Subject: Submittal of the Response to the Notice of Disapproval for the Investigation Work Plan for Upper Sandia Canyon Aggregate Area and Revision 1

Cross-Reference of NMED NOD Comments and Revisions to Upper Sandia Investigation Work Plan

Figure 4.1-53 Map N proposed sampling locations

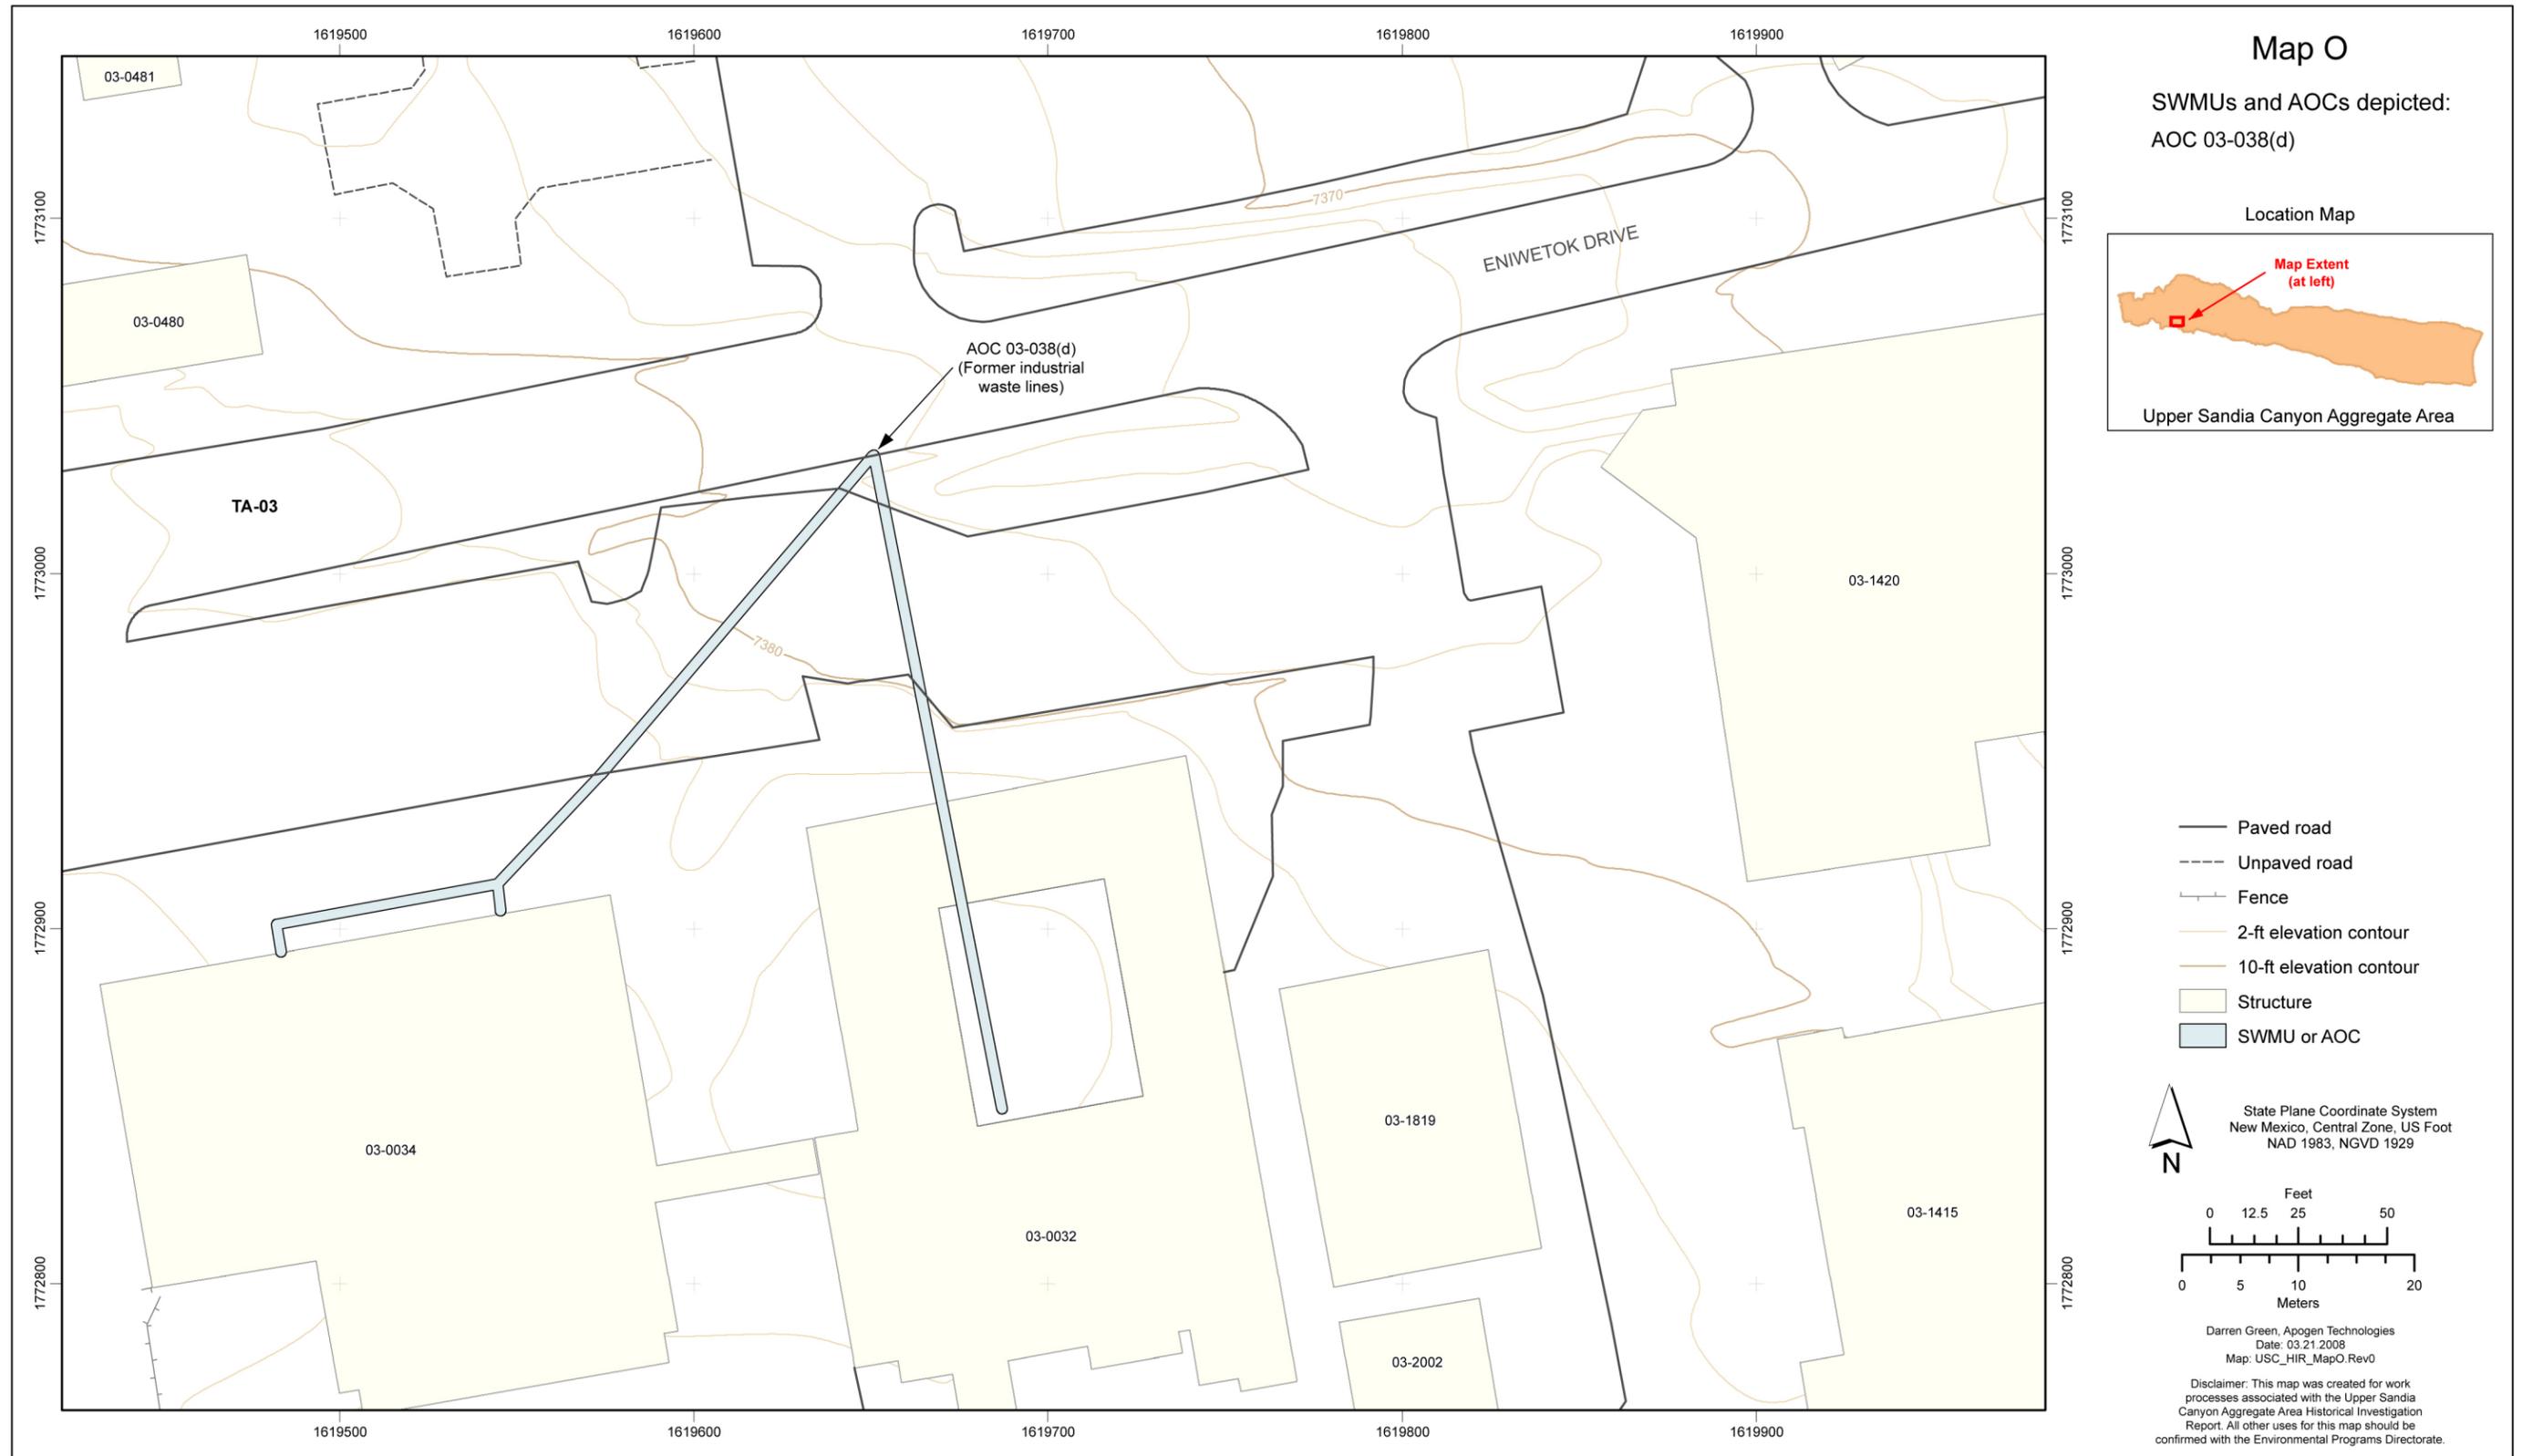
industrial waste line on the Figure 4.1-52. The Permittees must revise the figure to depict the location of the drainline from its influent source to the discharge point. In addition to collecting samples from the location where the former drainline exited building 03-0028, the Permittees must collect samples from the location where the former drainline discharged to the industrial waste line.

Figure 4.1-53 has been revised to show the location of the former drainline that carried rinse solutions to the industrial waste line and to show an additional sampling location where the former drainline discharged to the industrial waste line. The text in section 4.1.24 and Table 4.0-1 have been revised to include the new sampling location.

Figure 4.1-55 Map O proposed sampling locations

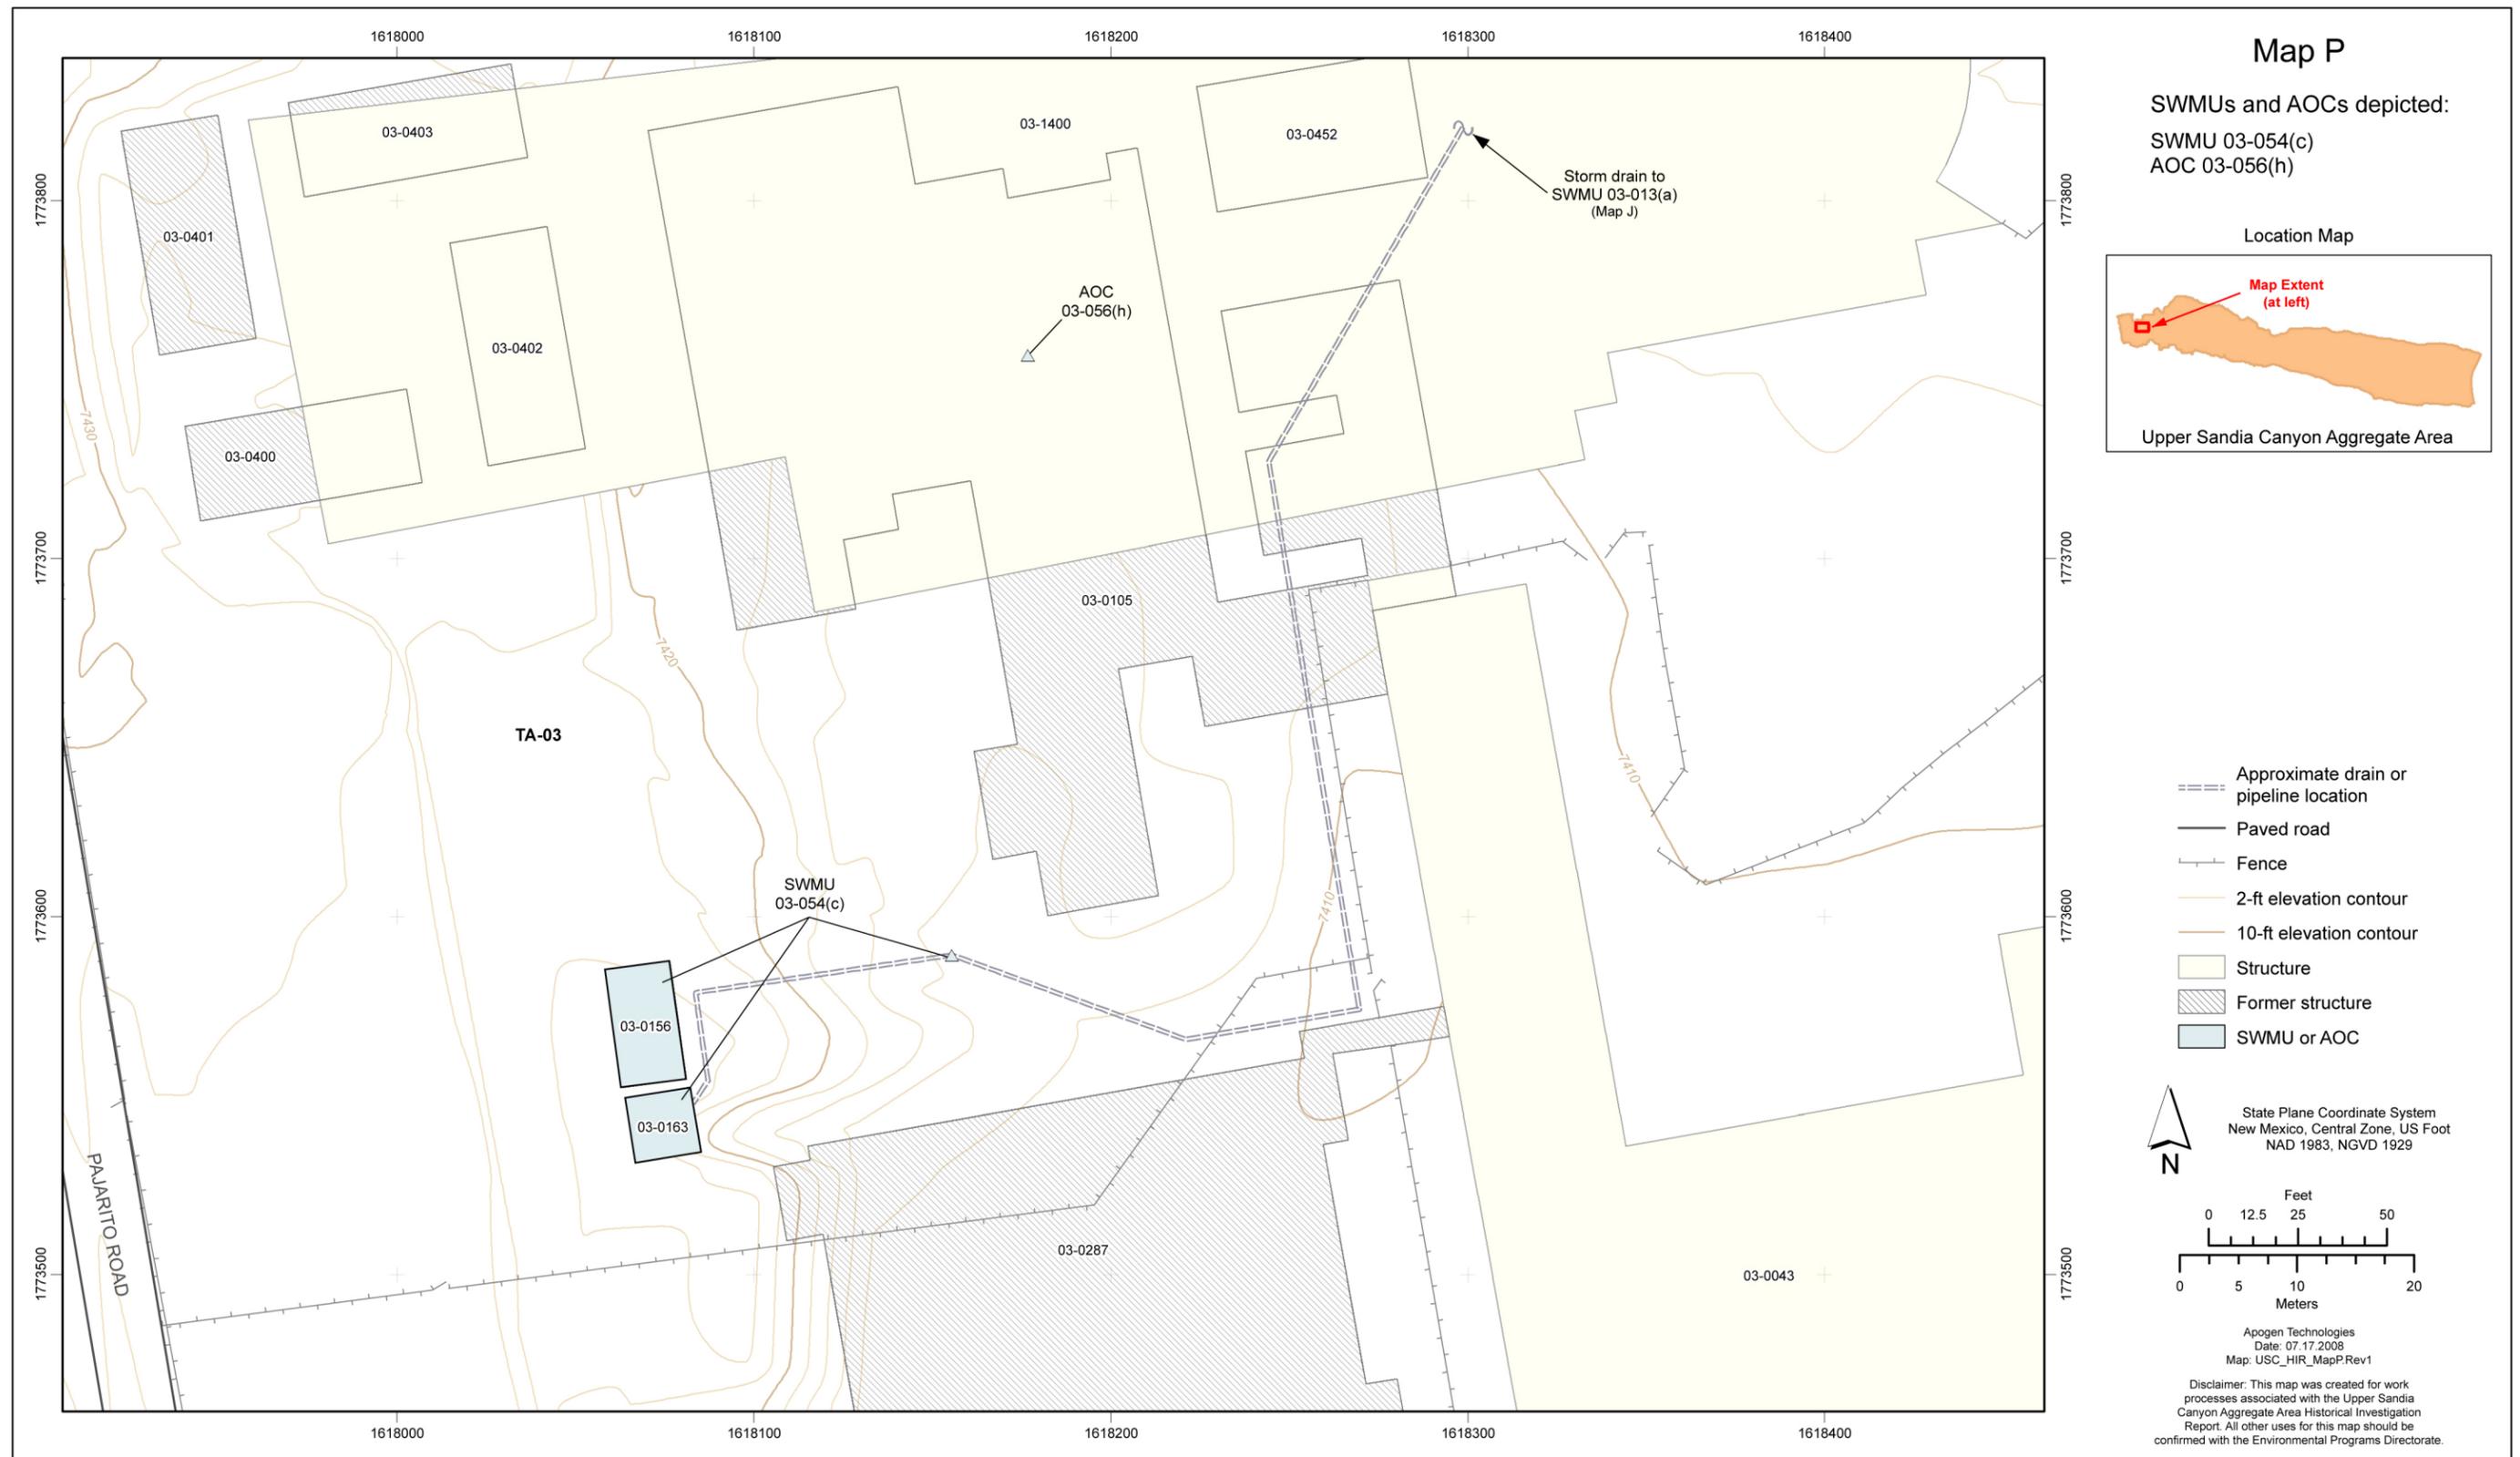
24	The Permittees must collect samples from the location where the drainline exited the oil pump house (structure 03-0057). The samples must be collected at two depths and analyzed for the same analytical suite as proposed in Table 4.0-1 for SWMU 03-045(e).	Section 4.1.30, Figure 4.1-24, and Table 4.0-1	Section 4.1.30, Figure 4.1-24, and Table 4.0-1	The close proximity of the diesel fuel storage tanks and associated fuel lines and other ancillary equipment for the steam plant makes collecting samples not possible at this time. However, LANL will investigate the drainline and area beneath the pump house after the demolition and decommissioning of the pump house. The text, figure and table have been changed to reflect this information.
25	The Permittees must indicate the orientation of the outfall pipe on Figure 4.1-13 and show the location of the drainpipe that carried effluent from the outfall pipe.	Section 4.1.32 and Figures 4.1-13 and 4.1-17	Section 4.1.32 and Figure 4.1-17	Figure 4.1-13 was not changed. Figure 4.1-17 has been revised to show the orientation of the outfall pipe and to depict the location of the drainpipe.

Figure 4.1-55 has been revised to include a new sampling location where the former drainline exited the building. The text in section 4.1.25 has been revised to describe the new sampling location.
